Intel® E8501 Chipset North Bridge (NB)

Specification Update

May 2006

Document Number: 309622-001

20. SMI Escalation via ERR[2:0]# Pins May Result in IERR#

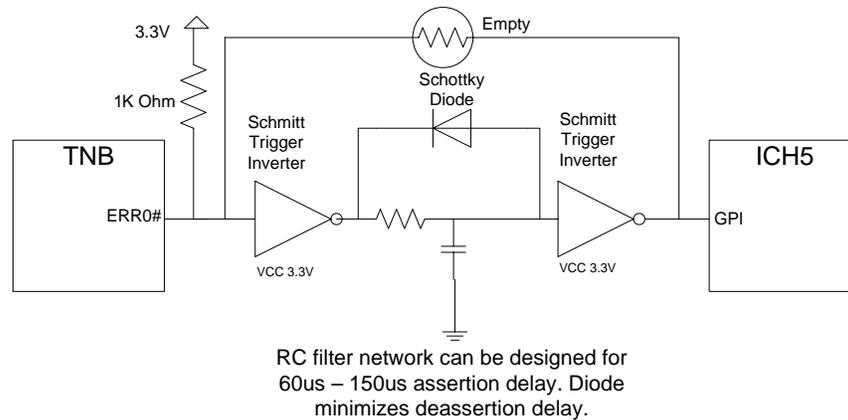
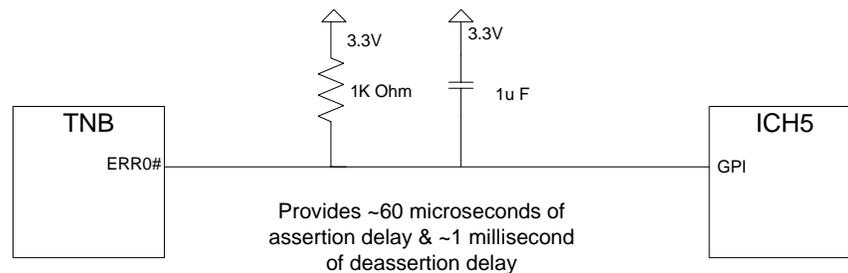
Problem: Any condition routed to MCH ERR[2:0]# output pins for SMI# escalation that would result in data poisoning on FSB will result in a CPU IERR# assertion due to race condition. The race condition exists between poisoned data presented to the FSB by the MCH and the uncorrectable error escalated to SMI# via ERR[2:0]# pins. If the CPU observes an SMI# assertion before the poisoned data is presented to the FSB, the CPU asserts MCERR# followed by IERR#. The CPU expects the SMI# assertion to occur at least 10 BCLKs after the associated MCERR# assertion. Conditions that result in data poisoning on FSB are uncorrectable memory ECC errors or poisoned TLPs received from any PCI Express* port.

Implication: CPU may assert IERR# and cause a system hang before the error may be logged in SMM.

1. Log errors upon reboot
 - System components (TNB, CPU, Southbridge) preserve errors across warm resets via sticky error registers
 - Requires a mechanism to reset system upon IERR# (server management controller, depress system reset button, etc.)
2. Delay SMI# assertion by inserting a 60µs-150µs delay on the ERR0# pin
 - Two recommended circuit solutions (other solutions may be possible):

- Route errors that result in FSB data poisoning to the ERR0# pin (IO4, M2, M4-13, M15)
